Project Title: Maverik - Comanche Princeton **Building Permit #:** _____ **Hydrology File #:** G16D029

**RE: TRAFFIC CIRCULATION LAYOUT
MAVERIK INC. C-STORE & FUEL STATION
3737 PRINCETON DR, NE 87107**

Re: Maverik Store
SW Corner of Comanche Rd. and Princeton Dr.
Traffic Impact Study
Engineer's Stamp dated 9-17-18 (G16-D029)

TRUCK MOVEMENT EXHIBIT

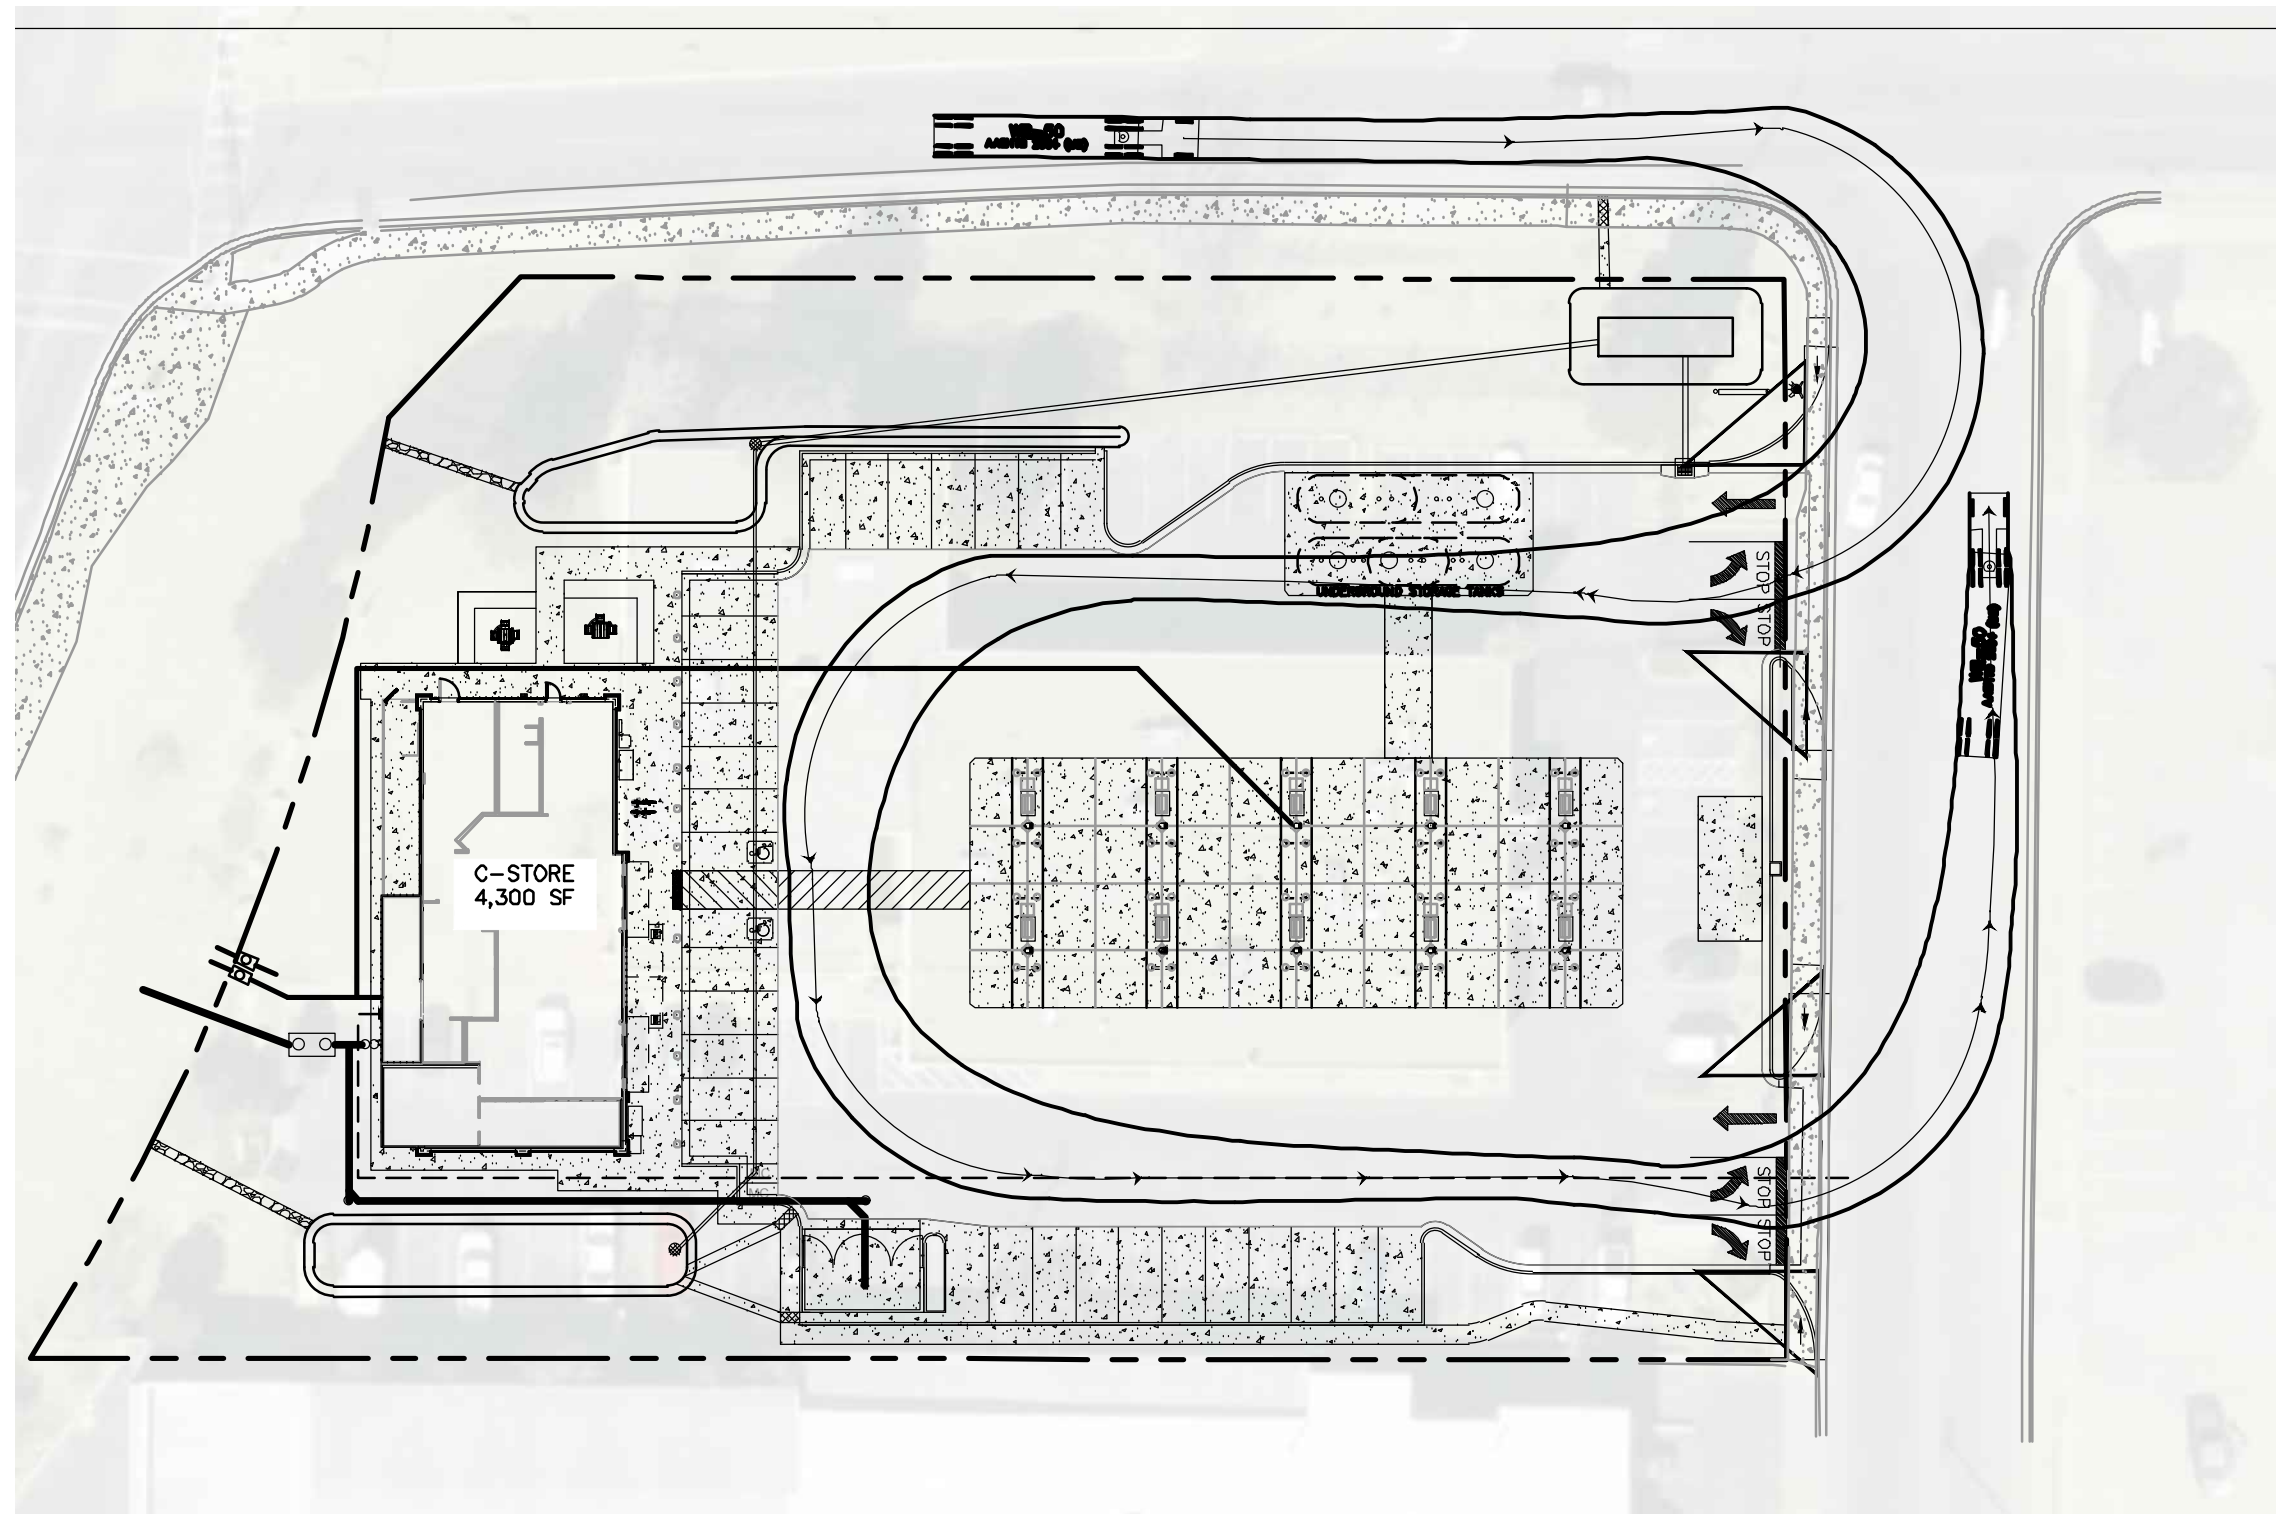
A truck turn movement exhibit is also being provided with this submittal to show the circulation movement of a WB-50, which is equivalent in size to the typical fueling delivery trucks that will be servicing the fuel station. All incoming and outgoing traffic will enter and exit through either the northern or southern driveway connections at Princeton Drive both driveways will not require any major infrastructure to Princeton Drive or have adverse impact to the adjacent properties from a traffic point-of-view.
